Item No. 1 - Addendum No. 2, Amendments to Drawings

Item No. 2 – Addendum No. 2, Amendments to Drawings, Item No. 7

Item No. 1 - Drawing A2.1

PROJECT NAME :
- PINEVIEW TERRACE LODGE NURSING HOME
-
- Prince Albert, SK

DWG. NO. :
S5.5-R2

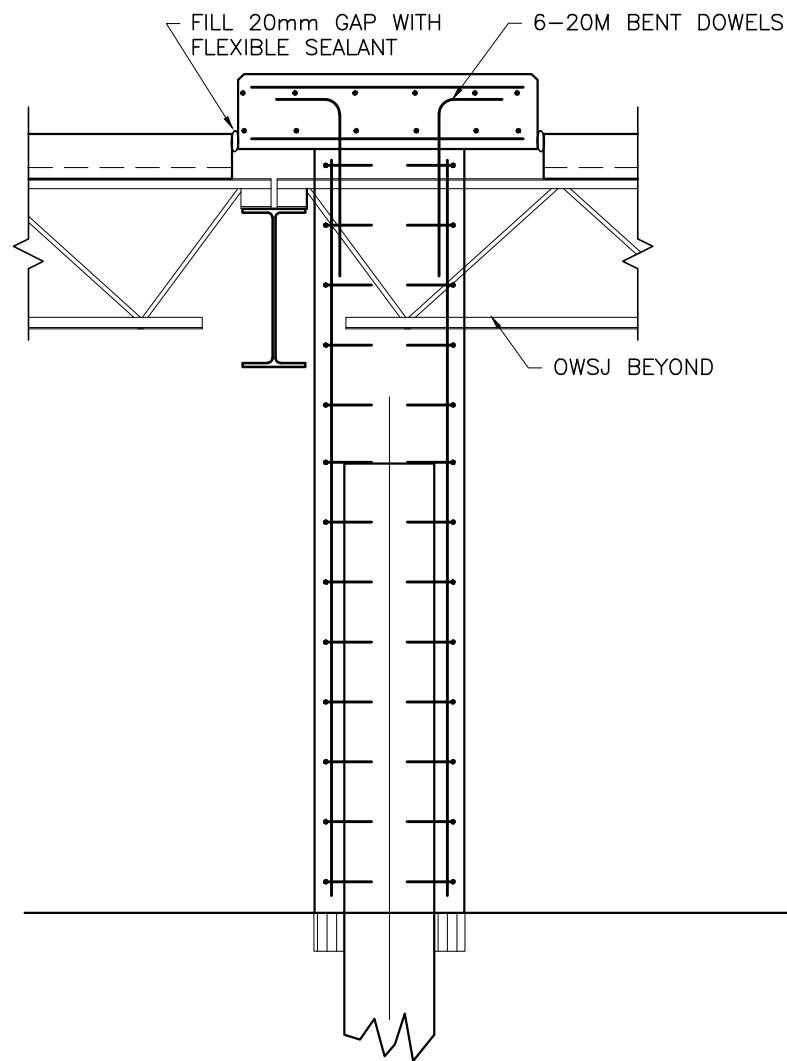
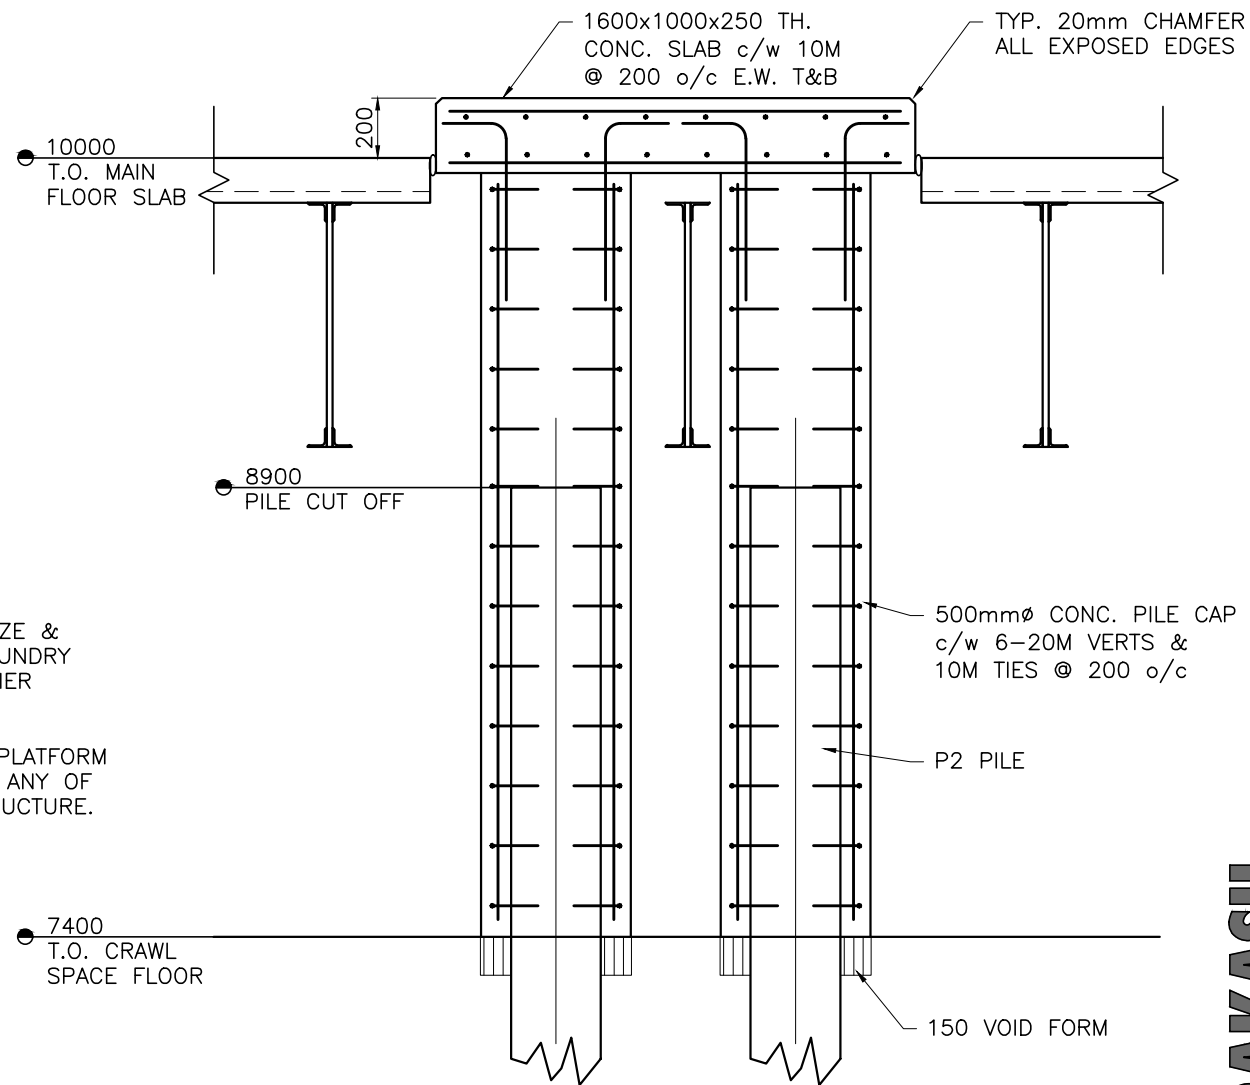
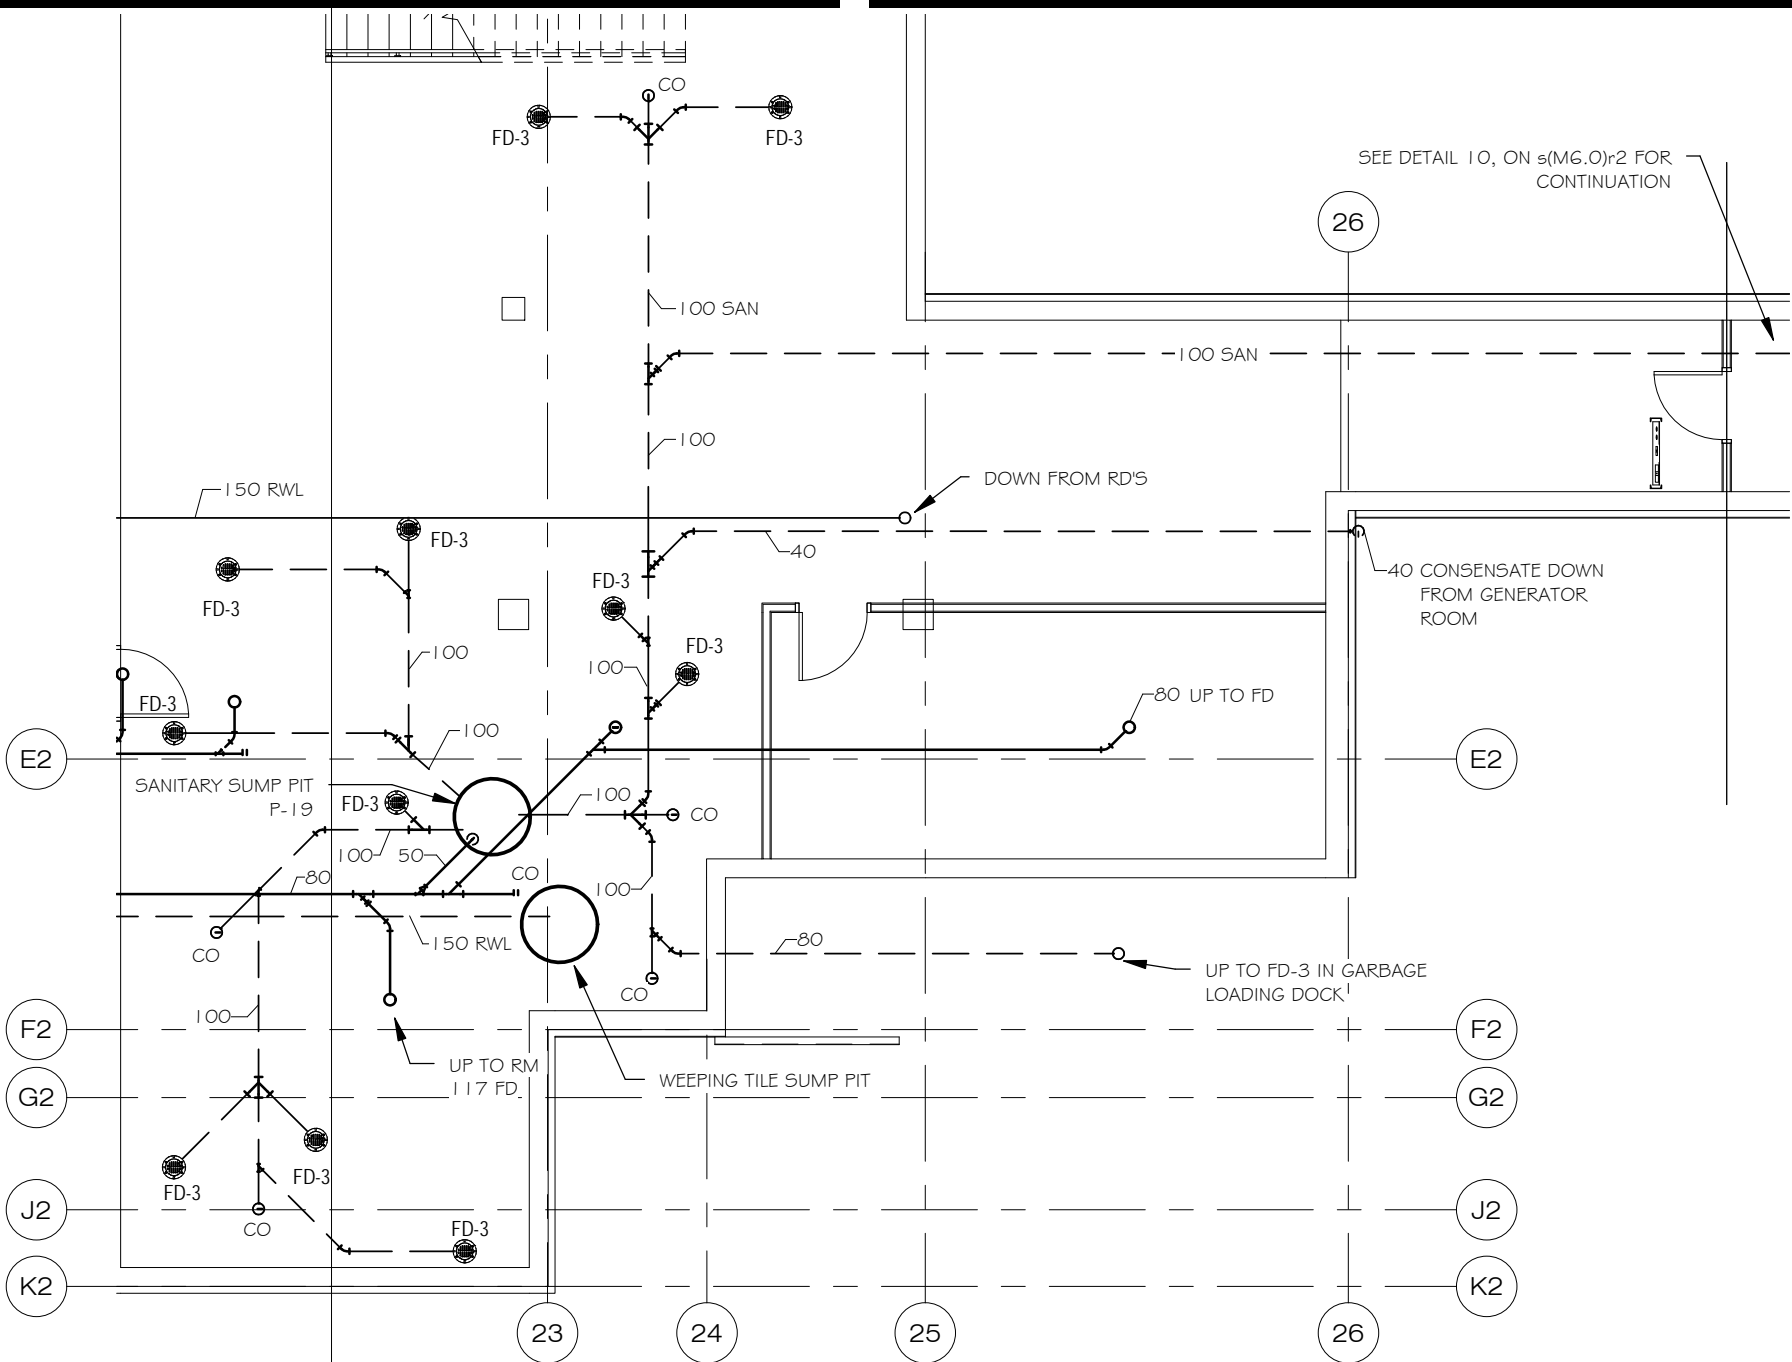
- .1 At 3A Helix Pile Notes
 - .1 Note 1. Change note 1 – Bearing stress below 6.0m depth should be 200 kpa Not 350 kpa.
 - .2 Note 4. Change note 4 – Report No S10-7460 should be No S10-7396
- .2 Add 2-P2 piles to support main floor housekeeping pad, see S5.5-R2. P.C.O. = 8900.

1. Column C7 of grid 15, u/s B.Pl. = 9890. Centre of C7 at 144 off of grid 15.
2. Provide separated slab 1000x1600 supporting washer & dryer. Separate from base slab on deck with 20mm gap. Refer to S5.5-R2 for reinforcing, dimensions and elevations.

10 Tunnel FD Piping

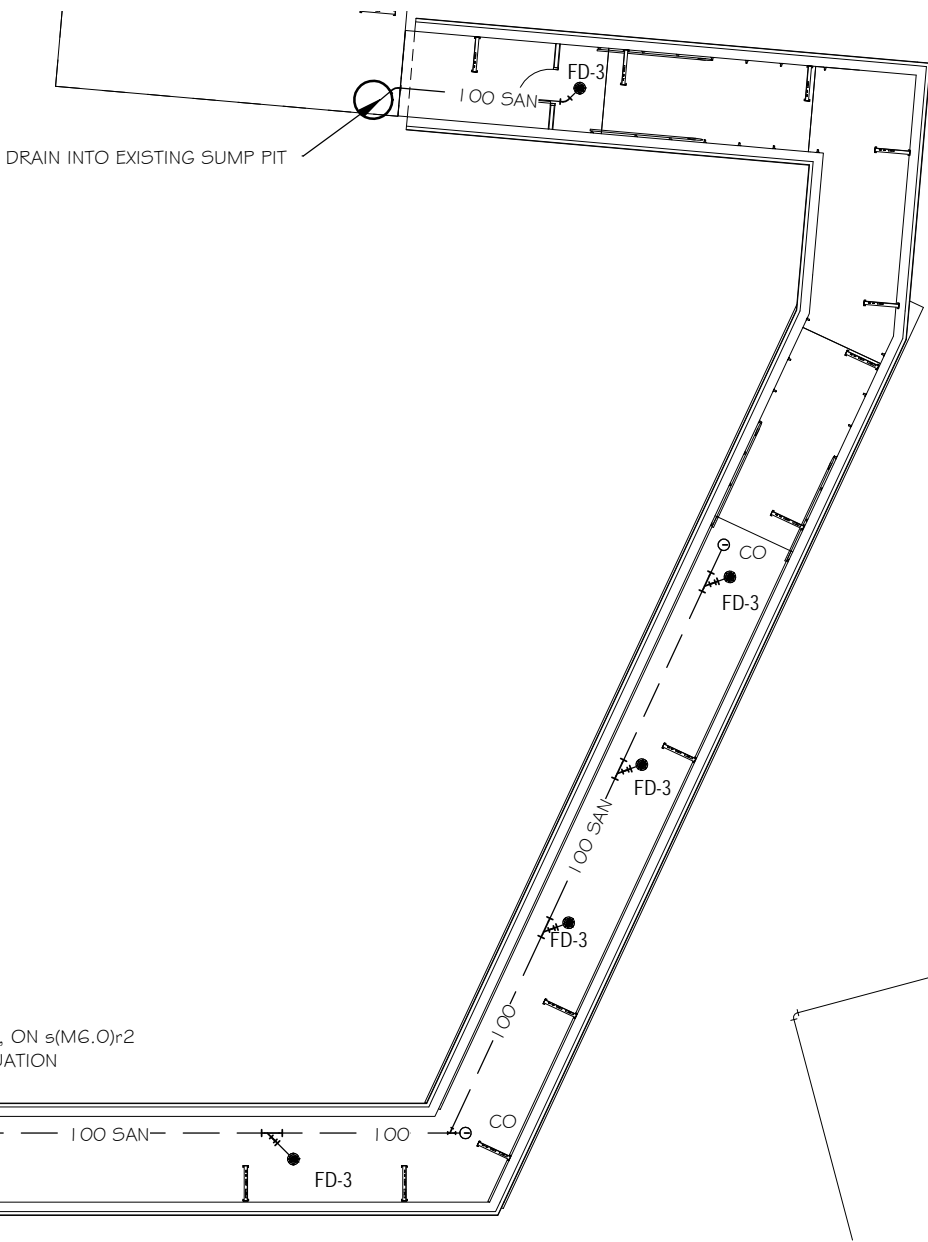
3. Detail 9 – Mechanical Room Floor Drain Plumbing: Revise detail as shown on attached drawing s(M6.0)r2. Mechanical room floor drains to drain to new sanitary sump complete with pump P-19. Provide sump pit as per Detail 12 on drawing M7.2, located between the heat exchangers.

4. Add Detail 10 – Tunnel FD Piping: Provide new FD-3 in basement tunnel as shown on attached drawing s(M6.0)r2.

DATE : 09 FEB 2012
PROJ. NO. : 09.038
DRAWN BY : MO
DWG. NO. : S(E2-2.2)r1

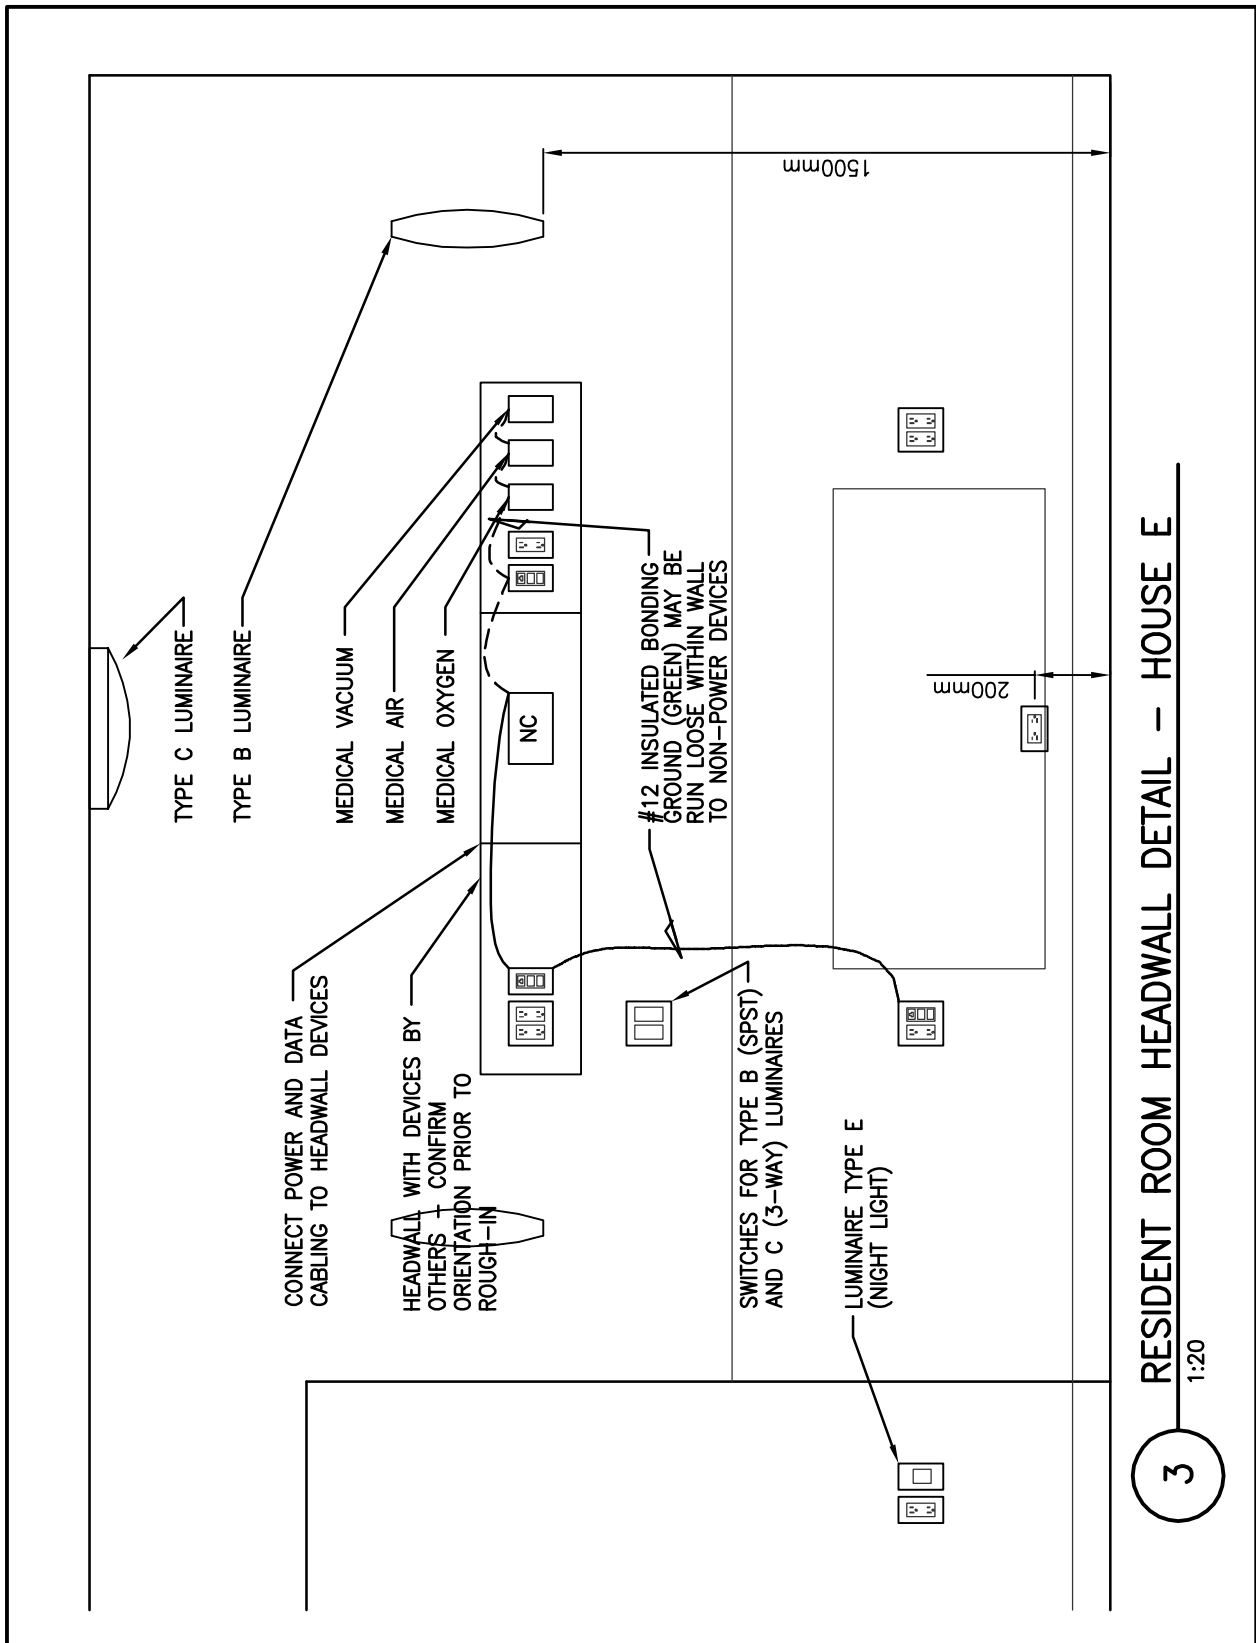
1. Add grounding as indicated in attached sketch S(E2-2.2)r1.

DRAWING NAME :
SINGLE LINE DIAGRAM

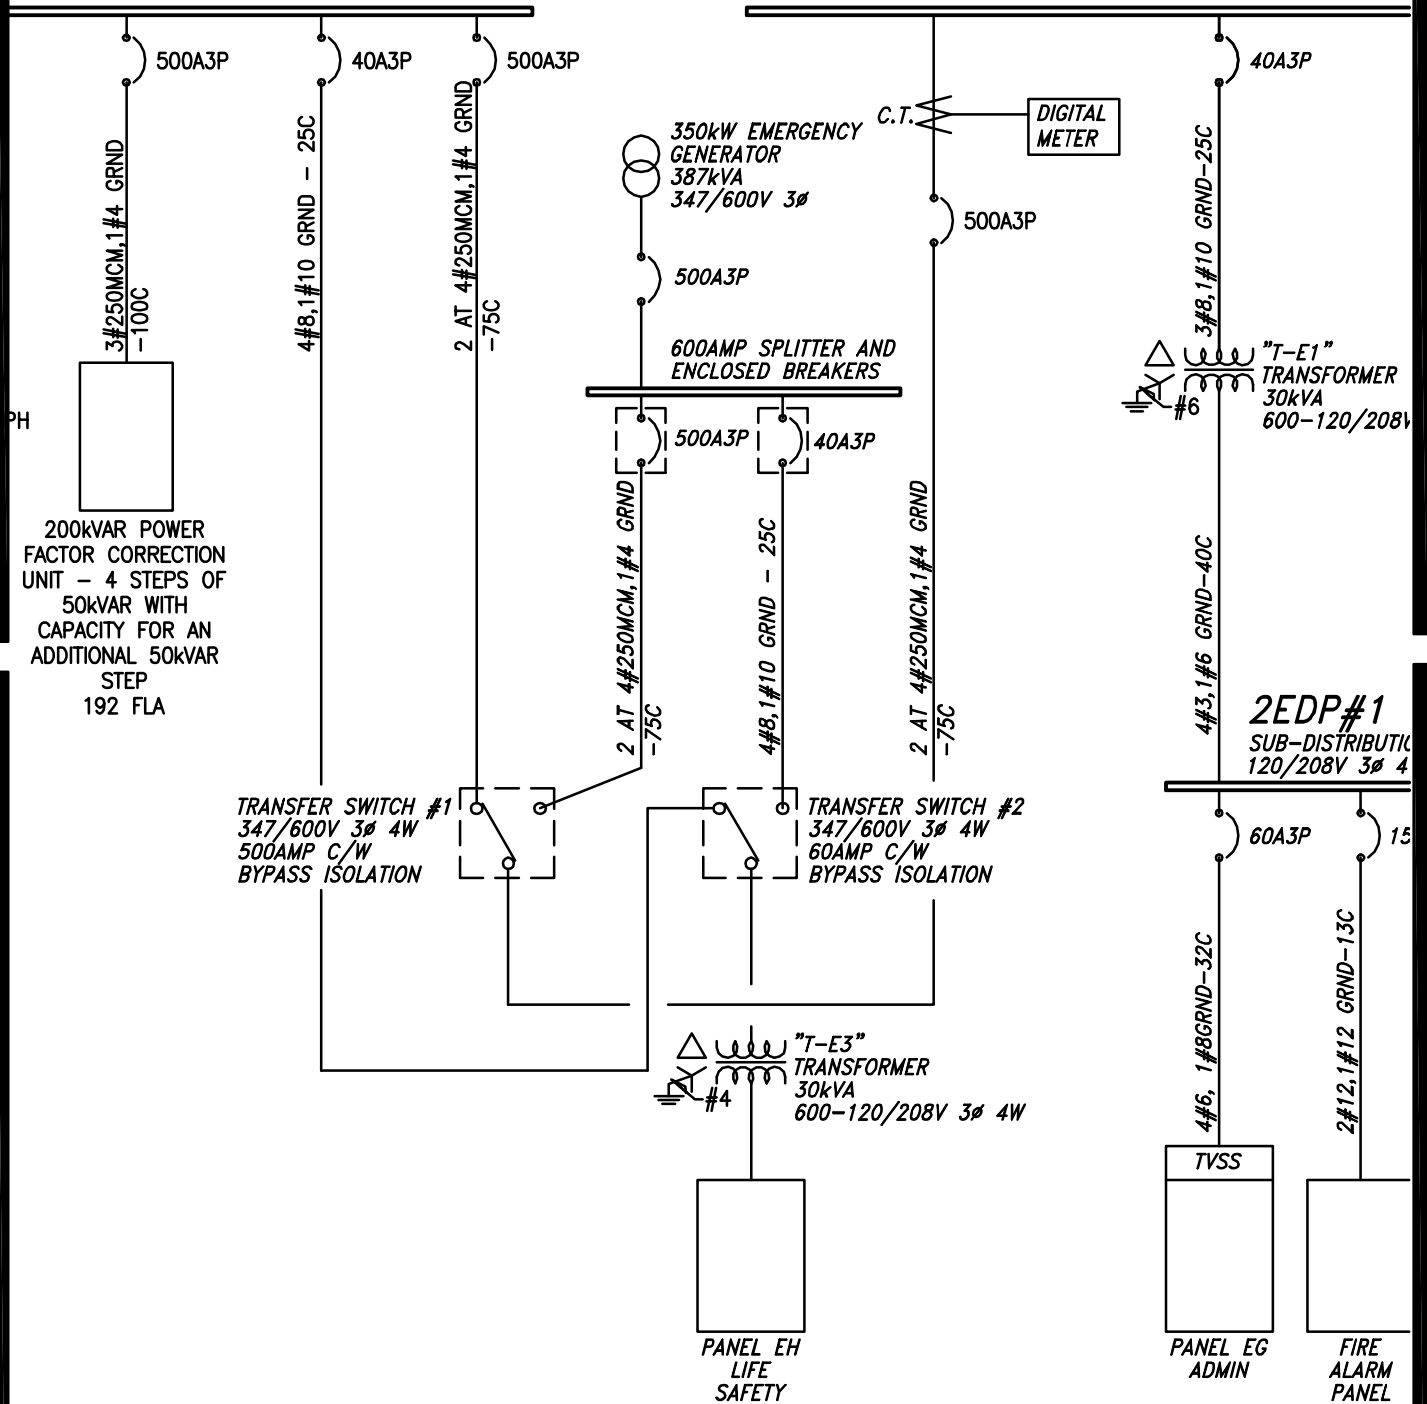
1. Refer to attached sketch S(E7-1)r1:
Provide and install a 600 amp 347/600V 3 phase 4W splitter on the load side of the 500 amp generator breaker. Provide a 500A3P enclosed breaker at the splitter to feed the 500 amp transfer switch #1, and a 40A3P enclosed breaker at the splitter to feed a 60 amp transfer switch #2. Transfer Switch #2 shall feed a 600-120/208V, 3 phase, 4 wire 45 kVA transformer "T-E3" and associated Panel EH (120/208V, 3 phase, 4 wire 60 circuit capacity). Locate Panel EH in General Storage 140 (beside Panel EF) and locate transformer "T-E3" in crawlspace below (suspend from floor structure). Normal side of transfer switch to be fed with 40A3P breaker in 6CDP#1.
